# **NRC Pre-Application Meeting TN-B1 Package Amendment And Letter Authorization Docket No. 9372**

November 29, 2021

## ■ Outer Container Shock Isolator Changes

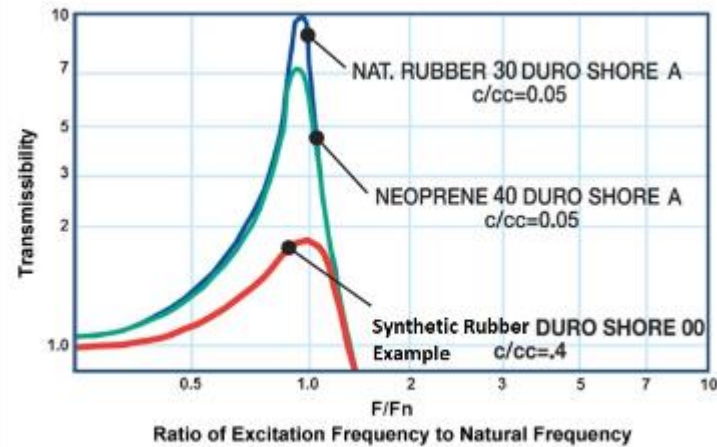
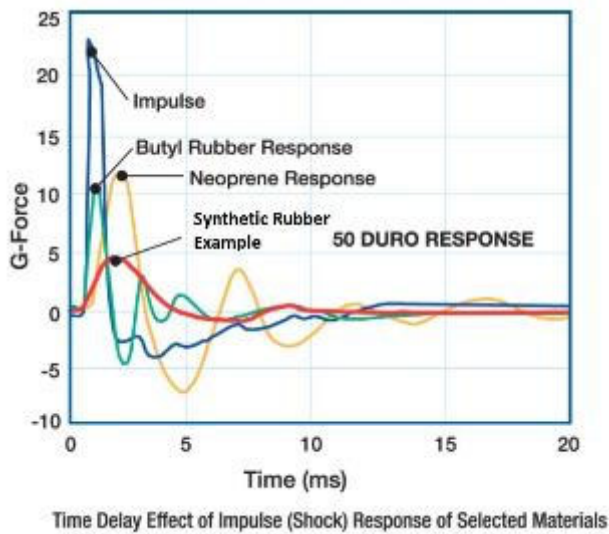
### ◆ Shock Isolator Material

- Currently defined as natural rubber
- Change material options to include synthetic rubber by eliminating “natural”
- No primary safety function, used to maintain fuel assembly quality
- Allow size variation, square versus round

### ◆ Includes Drawing and Text Changes

- From Natural Rubber to Rubber
- SAR Drawing 105E3740, Item 9 (shock Isolator)
- SAR Drawing 105E3739, Items 7, 8, 11 (rubber pads)
- Add note to each drawing allowing size and shape variation
- Section 2.2.2, *Chemical, Galvanic, or Other Reactions* (3 places)
- Rubber to be defined as neoprene, butyl, nitrile, natural or synthetic type rubbers
- Provide table with maximum defining limits (TBD) based on fuel assembly material control program
  - For example: Bromine = 150 ppm, Chlorides = 150 ppm, Fluorides = 150 ppm, Sulfur = 350 ppm

### ◆ Foam Absorber Pad Under Fuel Assembly

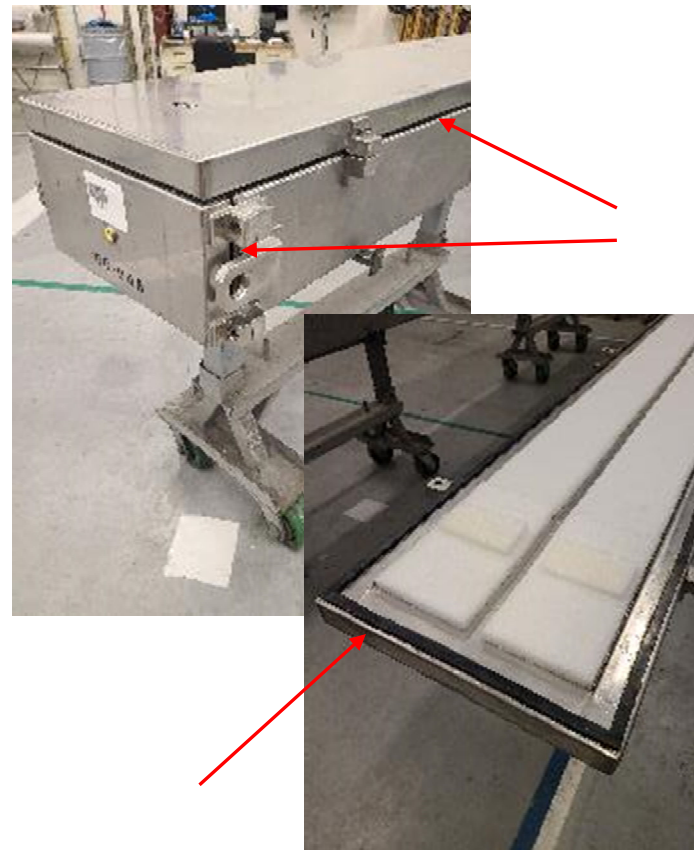
- Currently defined as Polyethylene Foam
- Change material options to include Polyethylene Foam or discontinuous strips of rubber
- Used to maintain fuel assembly quality, no change for NCT or HAC drops

### ◆ Includes Drawing and Text Change(s)

- SAR Drawing 105E3745, Item 40
- From Polyethylene Foam to Polyethylene Foam or Rubber
- Rubber to be defined as neoprene, butyl, nitrile, natural or synthetic type rubbers
- Within inner container, all foam and rubber to be limited by minimum overall thickness and a maximum density to allow for multiple vibration configurations.
- 1.2, Package Description
- 2.2, Materials / Structural
  - No effect, changes provide consistent function for vibration control
- 3.5, Thermal HAC
  - No effect, conservatively not modeled
- 6.1, Criticality Design, 6.12, *11x11 Criticality Design*
  - New maximum allowable density to be defined
- 7.4, Maintenance, Other Operations (no effective change)

### ◆ Gasket

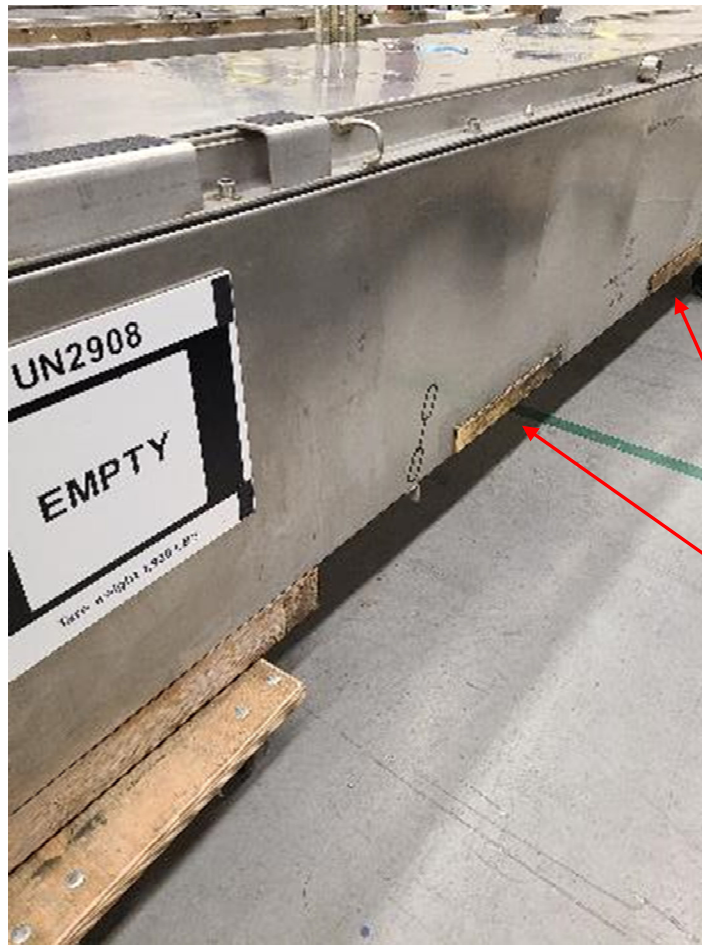
- Currently defined as Natural Rubber
- Change material options to Rubber or Neoprene
- No safety function, purpose of gasket is for dust seal not pressure retaining seal (Section 2.12.3)
- Containment boundary is the fuel assembly cladding

### ◆ Includes Drawing and Text Changes

- 105E3743, Item 12 (outer container gasket)
- 105E3743, Items 10 and 14 (inner container end lid gaskets)
- 105E3747, Items 17, 21 (inner container gaskets)
- From Natural Rubber to Rubber or Neoprene
- Material discussion in 2.2.2, *Chemical, Galvanic, or Other Reactions*
- Compression discussion in 2.12.3, *Outer Container Gasket Sealing Capability*
